RD/MECHANICAL SUPPORT DEPT.
CERENKOV COUNTER, PHOTOTUBE PLATE
PHOTOTUBE PLATE-E781 RICH

SCALE	DRAWING NUMBER	SHEET NO.	REV.
1/2=1; & NOTED	9213.150-ME-285771	1 OF 1	C

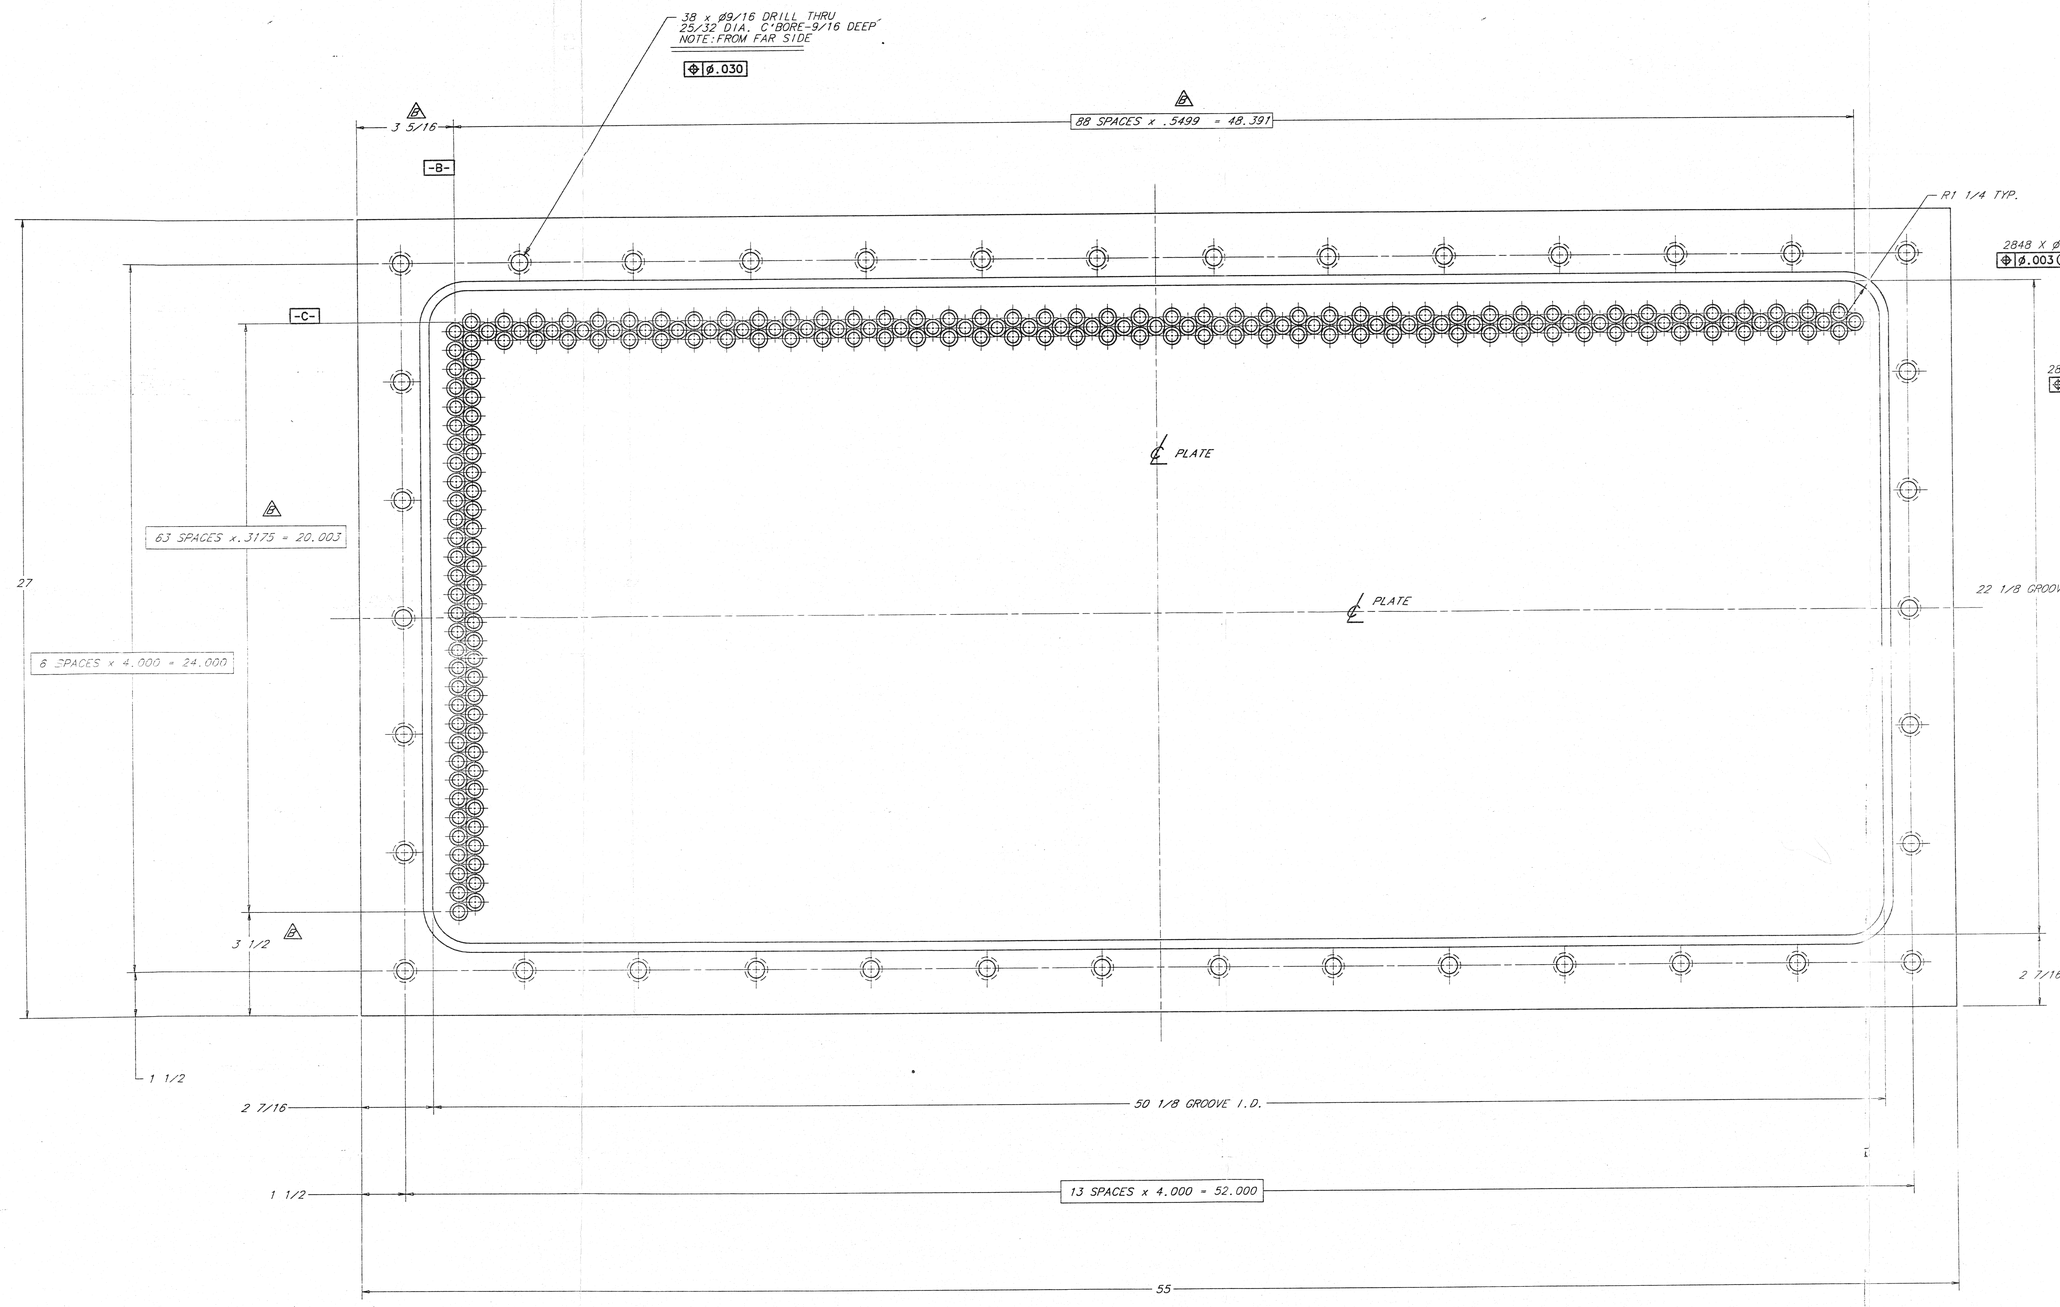
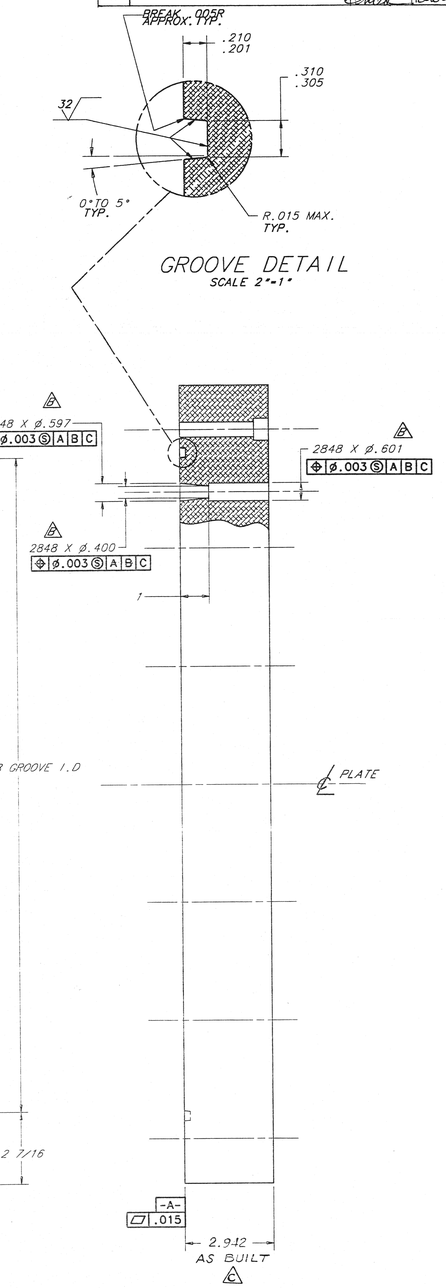
REV.	DESCRIPTION	DRAWN / APPROVED	DATE / DATE
A	VIEW A-A ±.001 TOLERANCES SPECIFIED.	A.SZ. / A.SZ.	4/13/93 / 4/13/93
B	1. HOLE SPACING (2848) CHANGED FROM .314 TO .3175 AND .3439 TO .3499. 2. Ø.601 WAS Ø.594, 3 5/16 WAS 3 3/16 & 3 1/2 WAS 3 1/2-32. 3. -TRUE POSITION TOLERANCING ADDED TO Ø.597, Ø.400 & Ø.601. 4. -VIEW A-A REMOVED. 5. -CHANGED CATEGORY TO 9213.150	RLW / JEB	5/93 / 20MAY93
C	2.942 DIM. WAS 3 STK.	RLW / [illegible]	10/94 / 10-10-94
